Access Compliance Report Public Rights-of-Way (RR Crossings)

Intersection ID: 13736	Main Street: CAMDEN_RD	Location: N/A
ADA ID: 8E977C0904DD	Overall Compliance: No	Severity Score: 0.0
Codes/Mitigation Info/Possible Solution		Field Measurements/Component Compliance

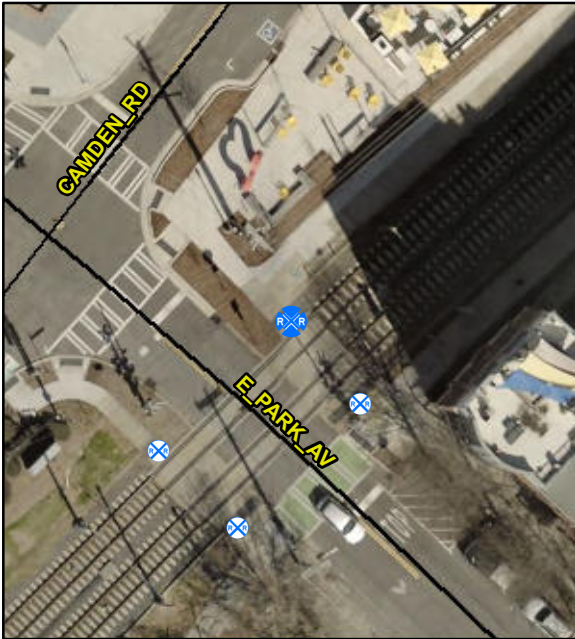
**Remove & Replace Detectable
Warning System. Provide Pedestrian
Gate. Remove & Replace Walking
Surface Adjacent to Rail.**

Compliance	Description	Data
Yes	DWS Provided?	Yes
Yes	DWS Contrast?	Yes
Yes	DWS Width (in)	Yes
Yes	DWS Length (in)	36.0
No	DWS Offset (in)	29.0
No	Pedestrian Gate?	No
N/A	DWS Outside Gate?	No
N/A	Rail Type?	LightRail
No	Flangeway Gap (in)	3.0
Yes	Sidewalk Width (in)	60.0

R302.7.4, R305.2.5
